State of New Mexico
Energy, Minerals and Natural Resources

South Culebra Bluff 23

SUNDRY NOTICES AND REPORTS ON WELLS

SCB #23-8
Loving East - 30-015-33605
Eddy County, New Mexico
Unit I; Sec 23; T23S; R28E; 1650' FSL & 330 FEL'
CURRENT COMPLETION; Updated by YIFL 2/18/19

SCB #23-8
Loving East - 30-015-33605
Eddy County, New Mexico
Unit I; Sec 23; T23S; R28E; 1650' FSL & 330 FEL'
PROPOSED WBD

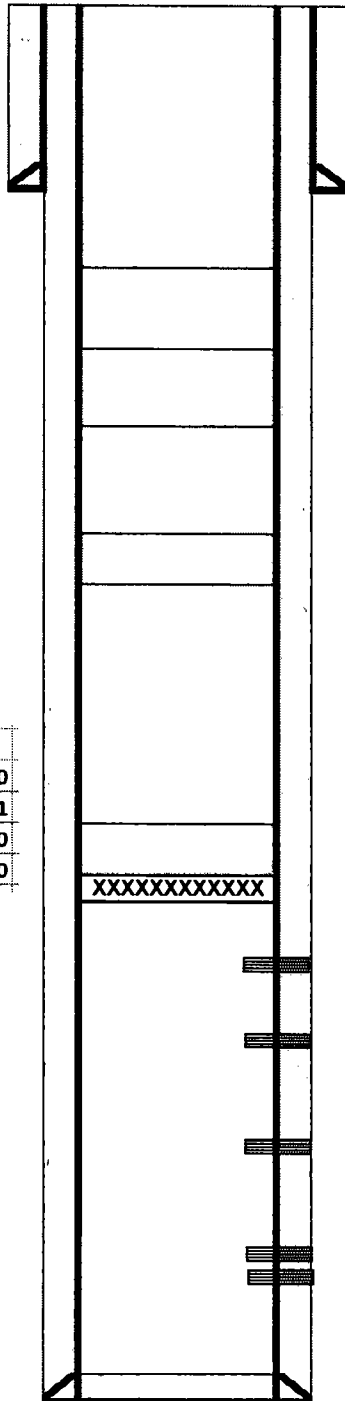
Spot 70 sx CL C cmt f/ 620' t/ surface (T. Salt, Shoe, Fresh Water)

Spot 45 sx CL C cmt f/ 2690' t/ 2301' (Delaware, B. Salt)

Spot 25 sx CL C cmt f/ 3569' t/ 3342' (DV Tool)

Spot 25 sx CL C cmt f/ 5950' t/ 5723' (Perfs)
 Set CIBP @ 5950'
